**CITY OF CEDARBURG
A MEETING OF THE SITE AND ARCHITECTURAL REVIEW BOARD
TUESDAY, JANUARY 20, 2026 – 8:30 AM**

PLANNER REPORT

PROJECT NAME:		Gerber Collision & Glass	PLANNER REVIEW FORM
PROJECT ADDRESS:		NW corner Sommerset Ave and Pioneer Rd.	
PROJECT DESCRIPTION:		16,617 sq.ft. motor vehicle collision repair business	
B-2 Community Commercial Zoning District Standards:			
The use "Motor Vehicle Collision Repair Facility" is listed as a conditional use in the M-2 District			
	Standard	Compliant	Not Compliant
Minimum Required Lot Size	40,000 sq. ft. minimum	X	Proposed lot size is 80,262 sq. ft.
Minimum Required Lot Width	150 feet, as measured at the abutting street right-of-way line.*	X	* A lot located in the business, manufacturing, or institutional districts which does not contain sufficient area to conform to the dimensional requirements of this chapter may be used as a building site provided that the lot is a lot of record in the County Register of Deeds' office prior to the effective date of this chapter. Substandard lots granted permits under this chapter shall be required to meet the setback and other yard requirements of this chapter. A building permit for the improvement

NEW BUILDING CONSTRUCTION FOR DSDH DEVELOPMENT
CITY OF CEDARBURG, OZAUKEE COUNTY, WI
SITE PLAN

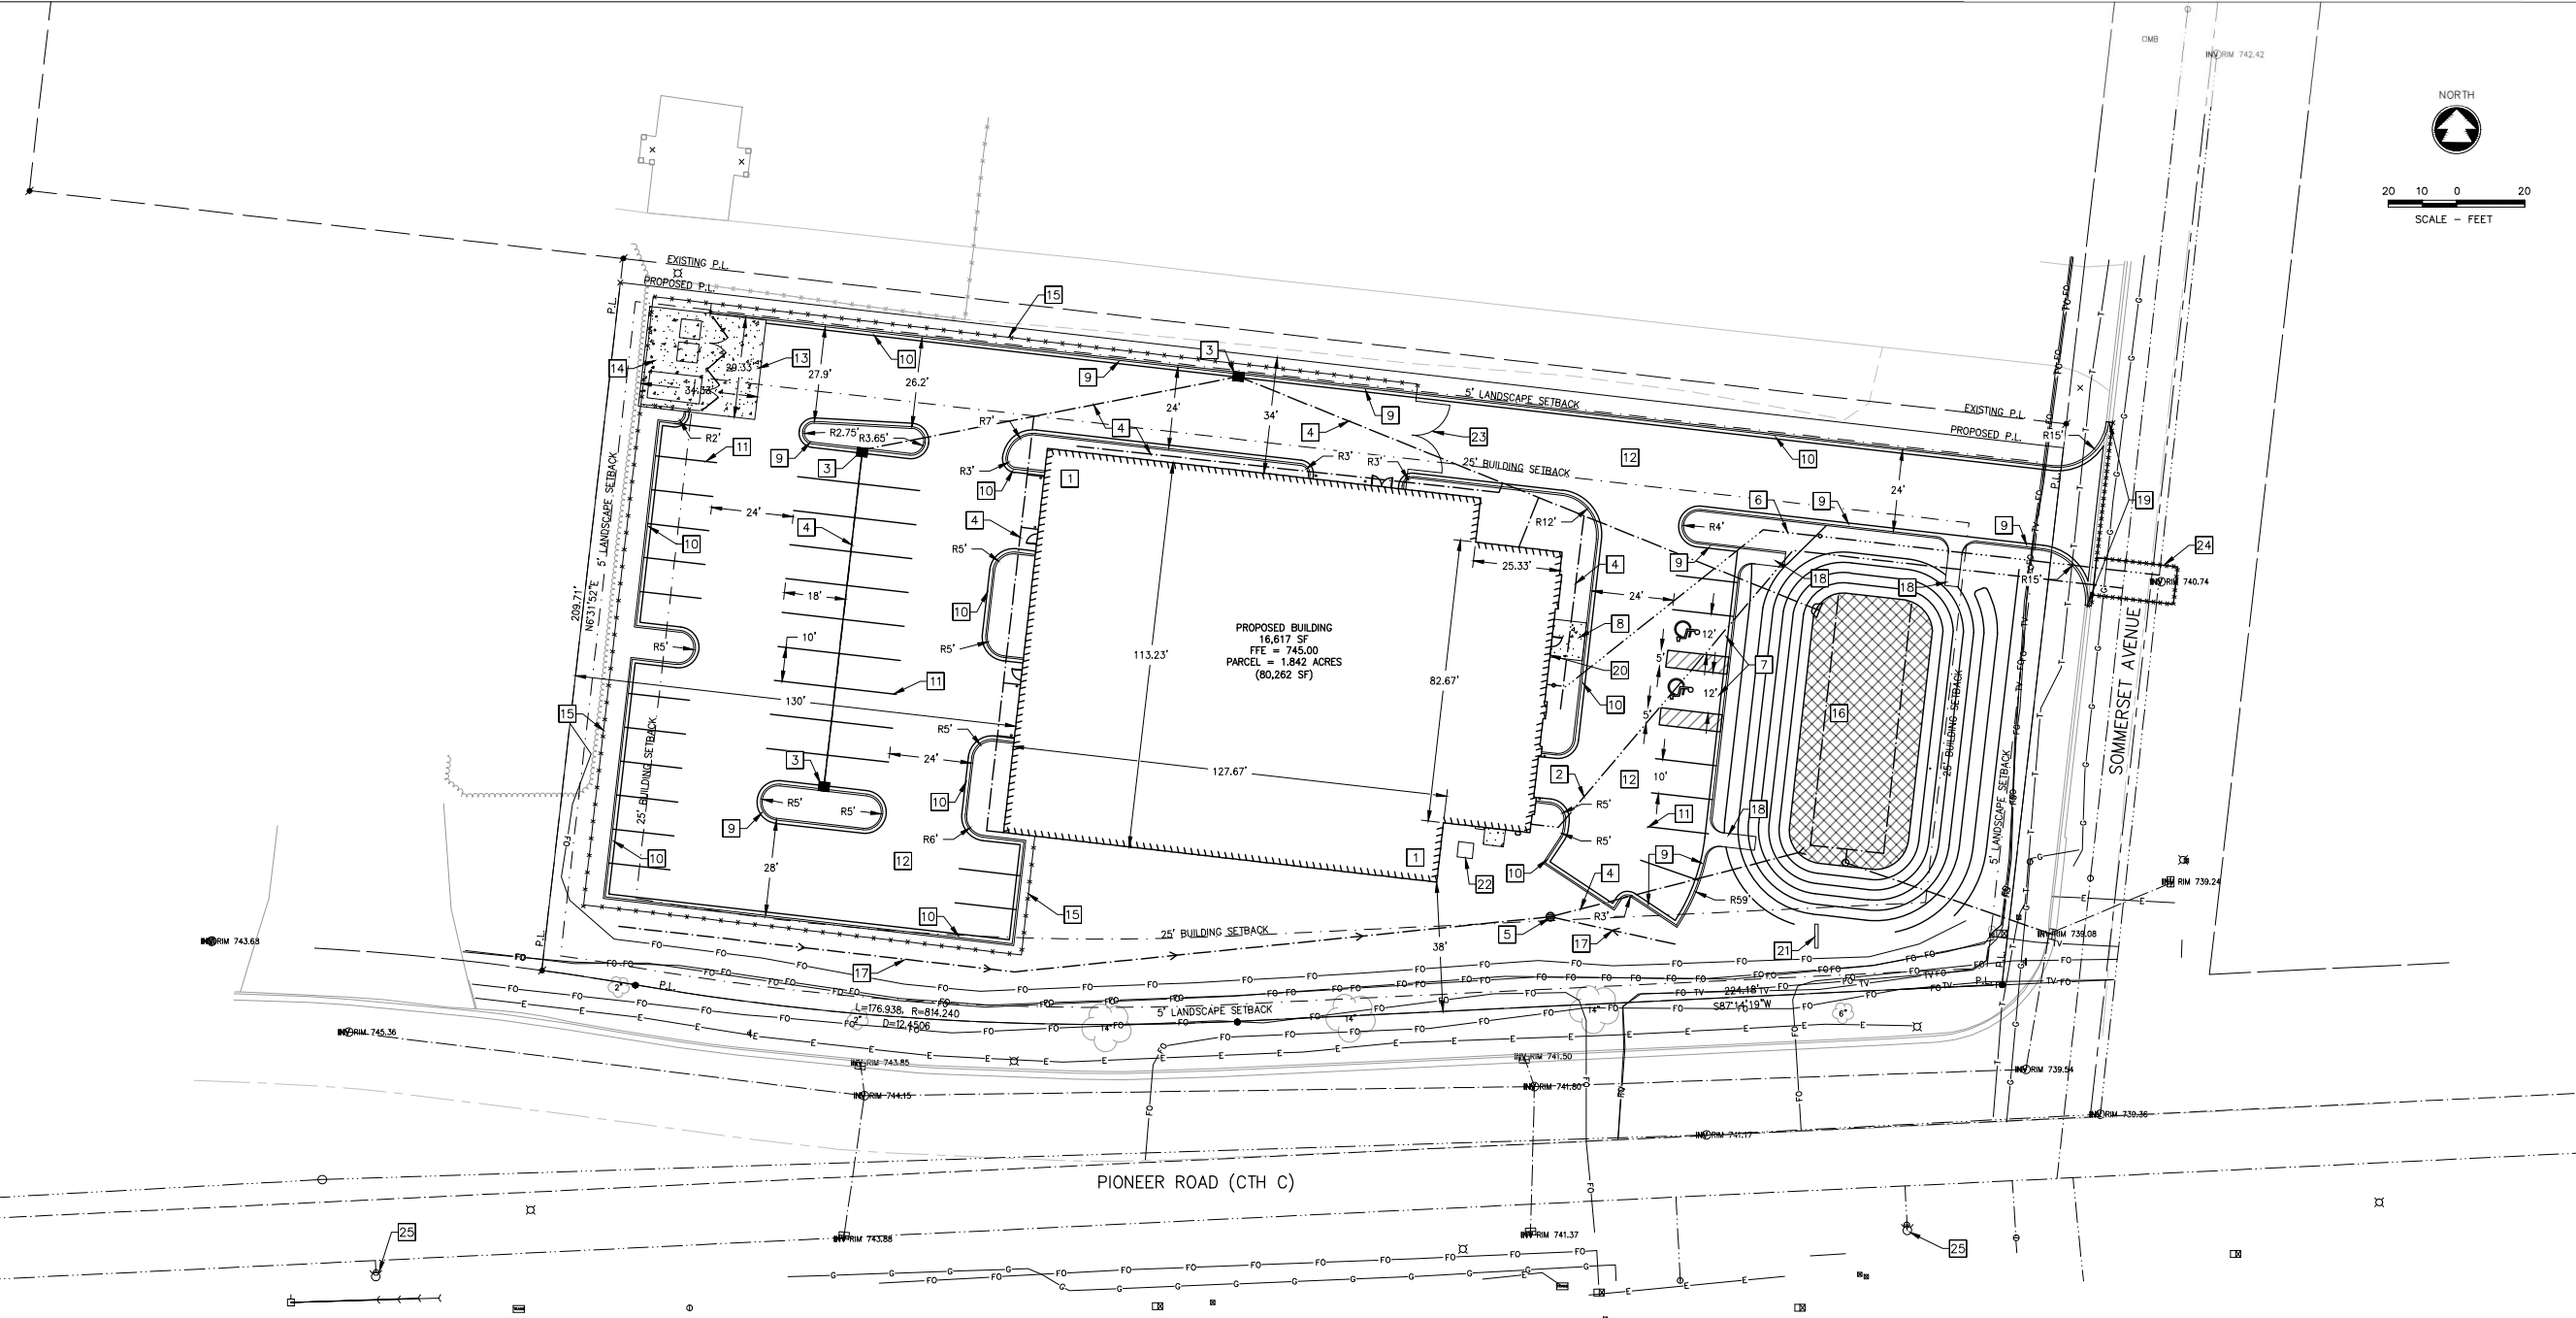
- There are six (6) City-owned right-of-way trees along Pioneer Rd., next to the proposed construction area (attached). Only four (4) of them are identified on their (the applicants) Planting Schedule. They are identified as Existing to Remain on the Plant Schedule. I ask that the Developer identify all six (6) public trees on their site plans with plans to retain. Please see attached Highlighted Excerpt form Policy PR-6 (attached).

- Timothy D. Martin, Water Utility Superintendent / Cedarburg Light and Water Utility
 - The 6" H2O service shall be connected to the existing 8" PVC water main in Somerset using a tapping saddle with a 6" gate valve attached at the main. Only other concern is the route being right on the edge of the retention pond downslope. Verify adequate cover is maintained. All other L&W construction specifications shall be adhered to.

- Mike Wieser, P.E., Director of Engineering & Public Works
 - Stormwater Management Plan must be approved by the City.
 - Sidewalk should be installed along Pioneer Road frontage.

- Side slopes of biofilter should be planted with turf grass that is mowed weekly with other turf grass.
 - I am ok with the sewer lateral to Sommerset as long as it's in the same trench as the water lateral.

- Connections to PVC sewer main must be made with PVC fittings.
 - Slurry backfill in the roadway.
 - Replace 5 inches of asphalt in trench.

- (b) The dimensional arrangement of buildings and structures conform to the required area, yard, setback, and height restrictions of this chapter. **Yes* Plan Commission must approve the area where the fence encroaches into the 25' street setback along Pioneer Road.**

LANDSCAPE DEVELOPMENT FOR
GERBER COLLISION AND GLASS
SEC Pioneer Rd & Somerset Ave, Cedarburg, WI 53012

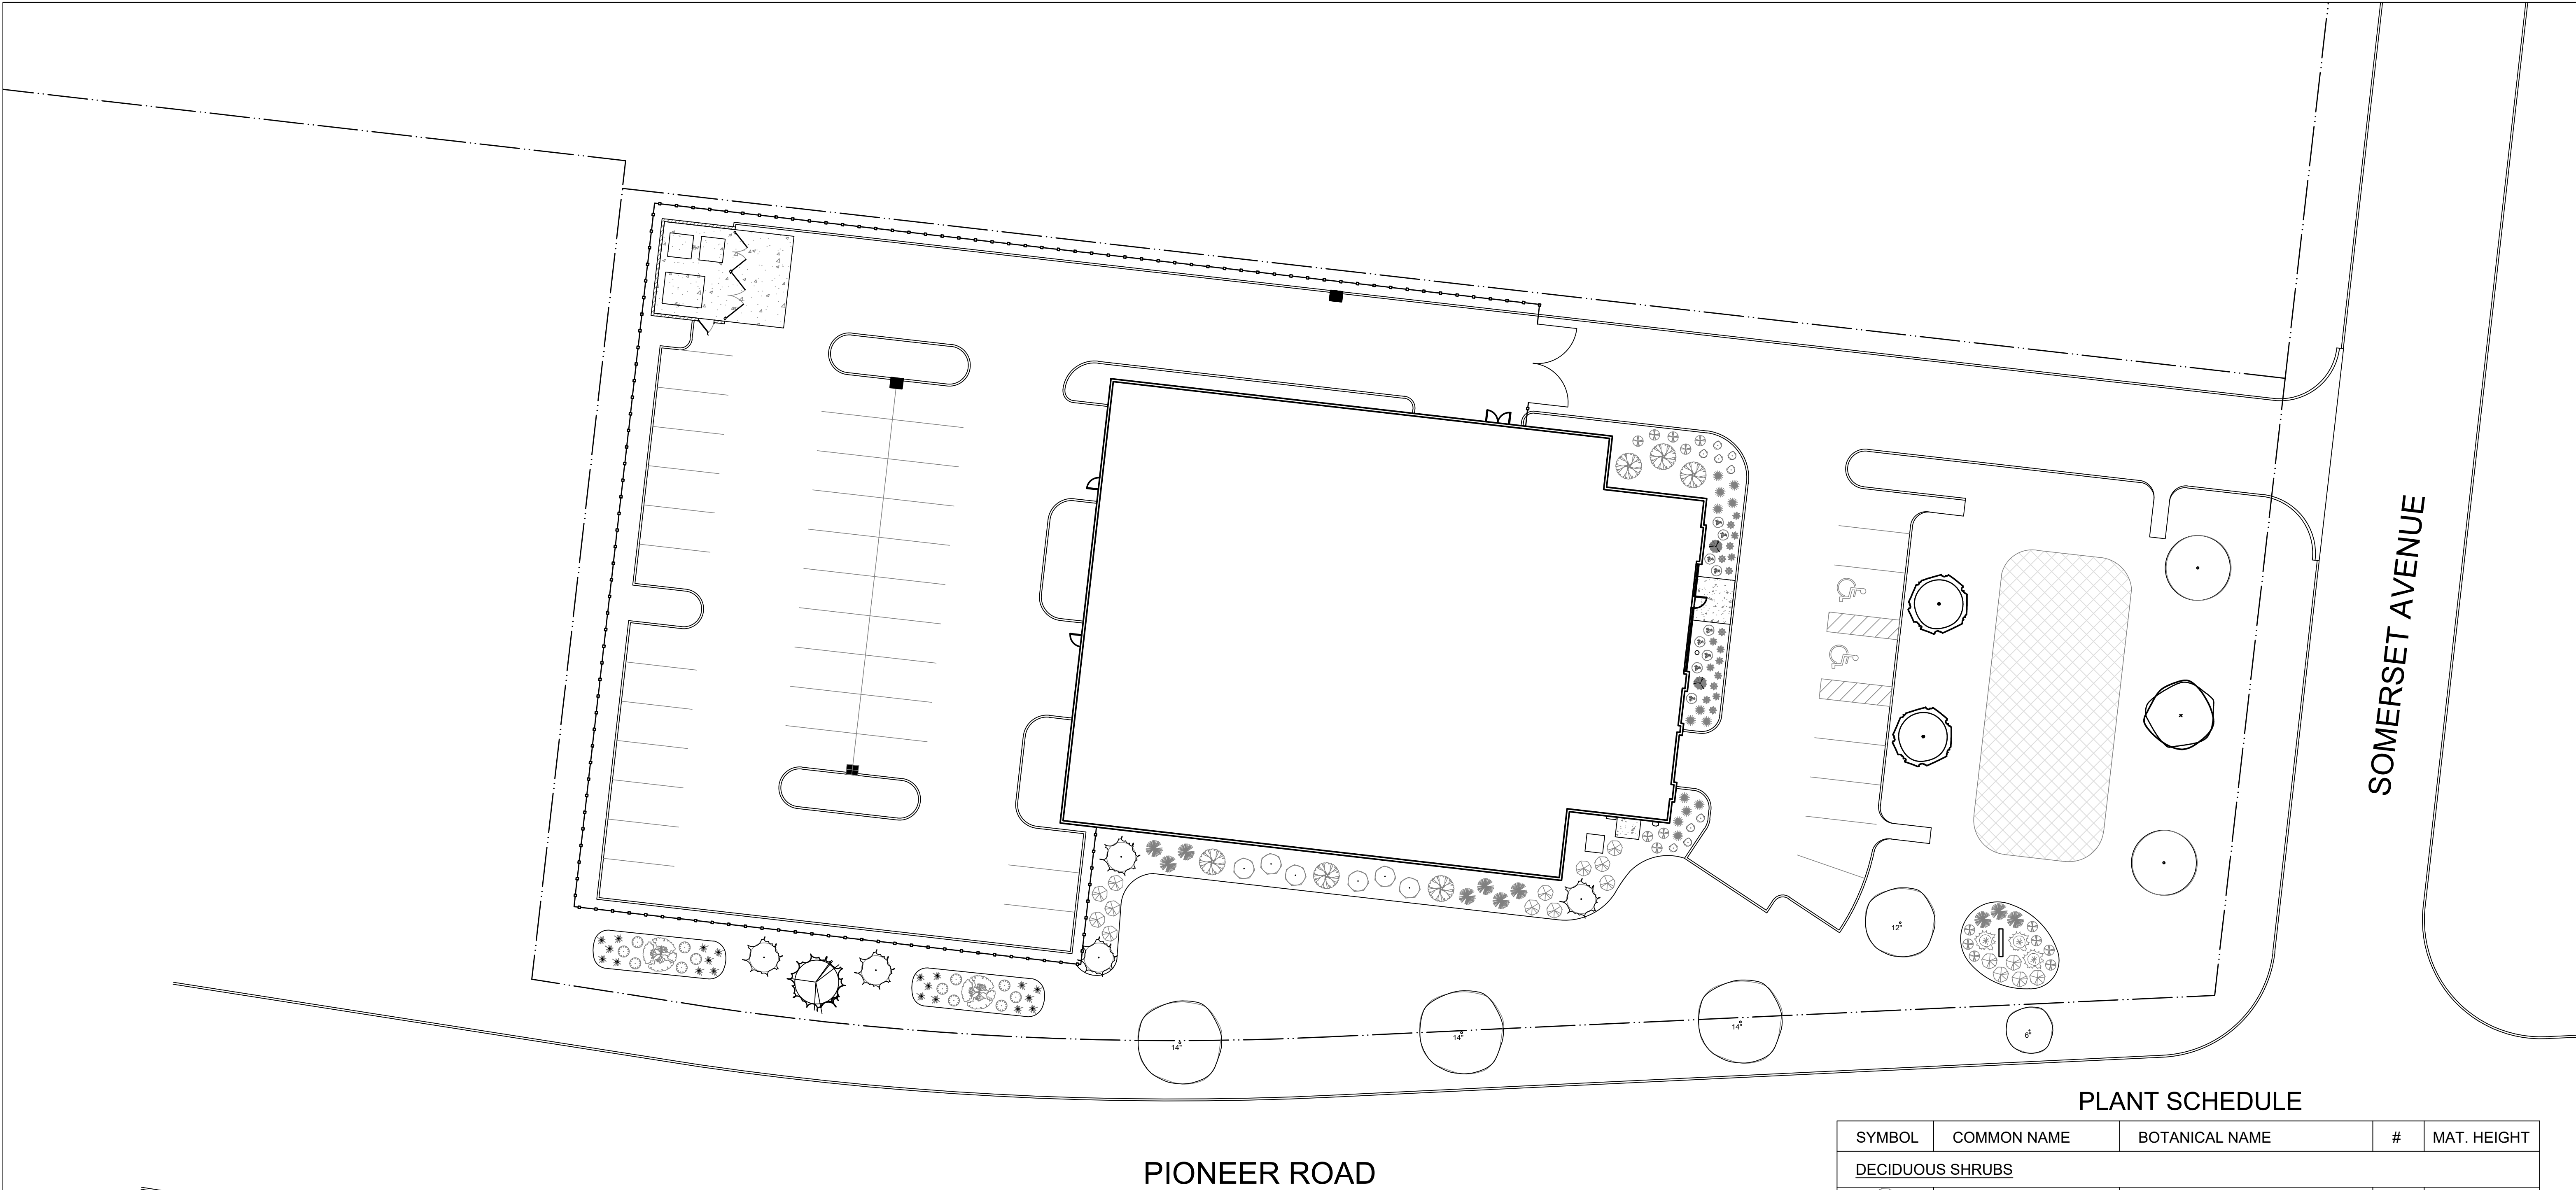
- 4) Applicant shall not damage or remove any of the existing mature trees located along their west lot line.
- 5) All areas on the landscape plan highlighted light green shall be mowed turf grass. This includes the areas along the north and west sides of the fence and the slopes of the detention pond.
